THE COUNTY OF CHESTER

PLANNING COMMISSION
Government Services Center, Suite 270
601 Westtown Road
P. O. Box 2747
West Chester, PA 19380-0990
(610) 344-6285 Fax (610) 344-6515

Re: Sketch Plan - Stokes Property
Westtown Township – SD-12-20-16556

Sketch Plan Detail – Stokes Property

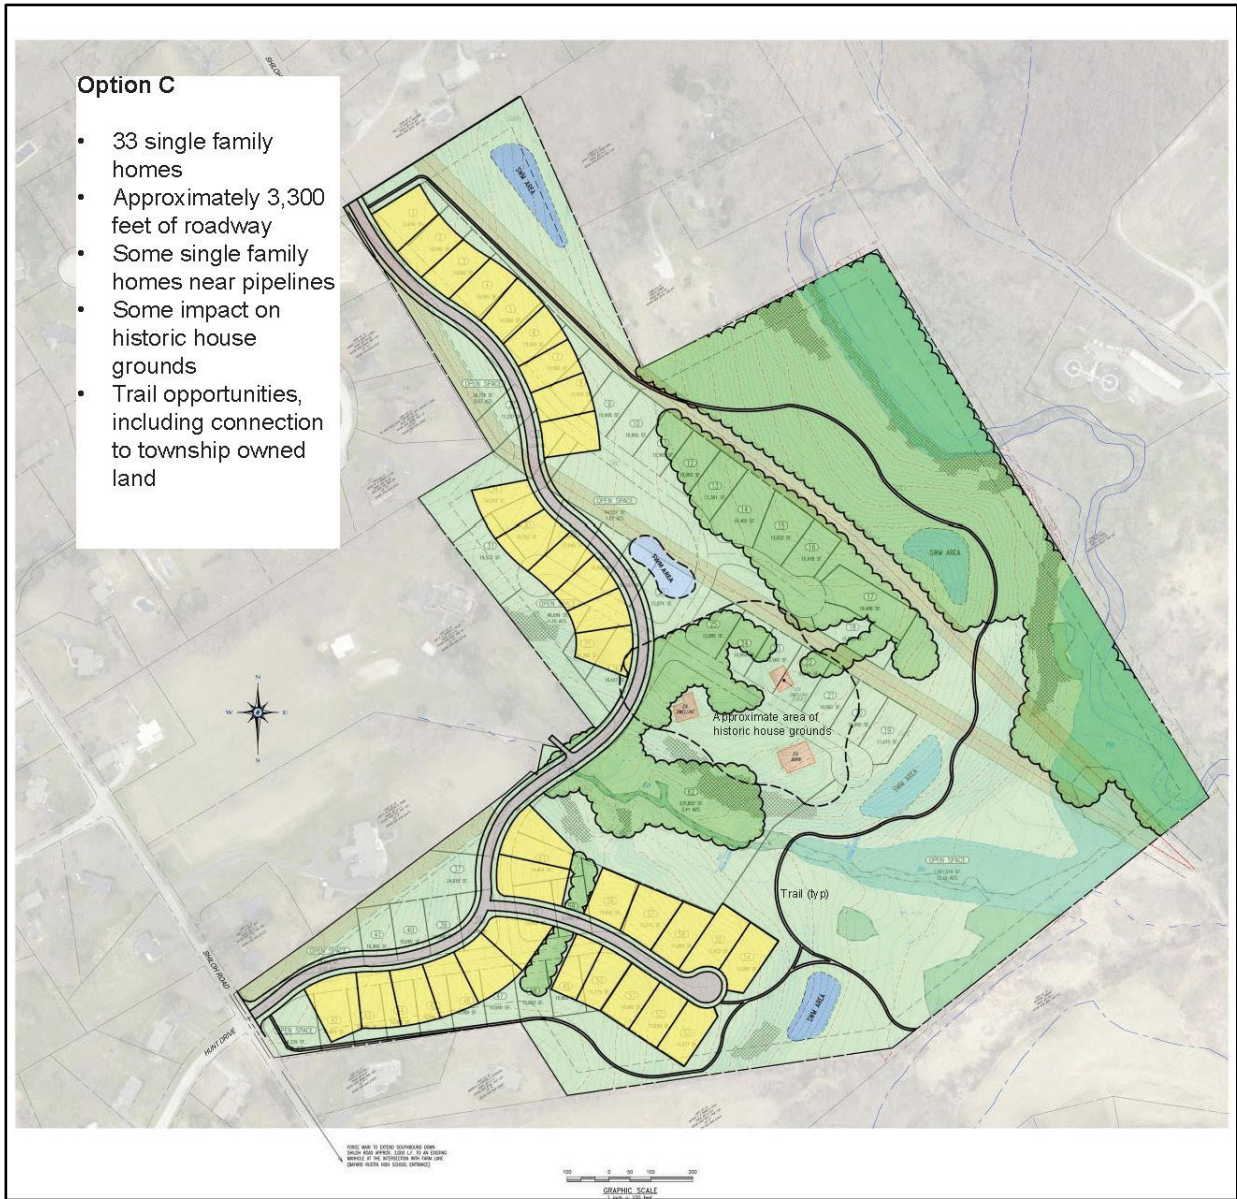
- Our copy of the Township Historic Resources Map indicates that the site contains a Class 2 historic resource, and we acknowledge and endorse that the density calculation table indicates that the applicant is requesting a bonus density for the restoration/rehabilitation of the historic resource. The Township should reserve granting final plan approval until the proposal has been reviewed by the Township’s Historical Commission. “Appreciate” Objective A of *Landscapes3*, the 2018 County Comprehensive Plan, is to preserve historic resources in their context while supporting appropriate reuse as a vital part of our community infrastructure and character. Additional information on this issue is available online at: www.chescoplanning.org/Landscapes3/1c-Appreciate.cfm.

3. The project site is traversed by two hazardous liquid transmission pipelines. Applicants should be aware that the actual location of the pipeline may not always be within the center of the easement or right-of-way. To minimize risks before and during construction, the project designer should contact the Pennsylvania One Call Center at 811 or <http://www.pa1call.org/pa811>, consistent with the provisions of Section 4(2) of Act 287 (Underground Utility Protection Act), prior to finalizing the design. The PA One Call Center should also be contacted at least 3 business days, but not more than 10 days, prior to any excavation. More information about pipeline safety can be found at the Chester County Pipeline Information Center at: <http://www.chescoplanning.org/pic/introduction.cfm>.

4. The applicant should identify if a stop sign will be provided for the proposed entrance at the Shiloh Road/Hunt Drive intersection. Due to existing slopes, and numerous intersecting streets to the north and south, there is the potential for sight distance issues at this intersection.

5. We recommend that sidewalks be provided for this development. Sidewalks are an essential design element for new construction in the **Suburban Landscape**.

6. The Parks and Open Space map in the Township’s 2019 Comprehensive Plan indicates the project site adjoins the Plumly Farm municipal open space area to the south. We recommend that the applicant and Township incorporate trails into the design of the proposed open space, including connection(s) to the proposed trail corridor on the adjoining Plumly Farm site depicted on the Trails and Bikeways map in the Township’s Comprehensive Plan. We also recommend that the applicant and Township consider utilizing all-weather materials in the construction of all trail corridors, which will accommodate a wider variety of uses, and be handicapped-accessible.

7. We recommend that, due to the topography of the area, the applicant and Township consider providing landscaping/buffering that exceeds the minimum requirements in the Township Code. In particular, there should be significant areas of landscaping provided between the proposed development and the neighboring properties in the vicinity of Shiloh Road, the Hawthorne subdivision, and Shippen Lane.

8. Due to the existing physical and environmental constraints of the project site, we recommend that the applicant and Township consider the alternative sketch plans provided on pages 6 through 8 of this review letter. We note that all three options provide for trail corridors within the open space, which extend to the Plumly Farm municipal open space area to the south, and reduce the overall length of the proposed roadway network (approximately 4,630 linear feet in the current sketch plans submission).
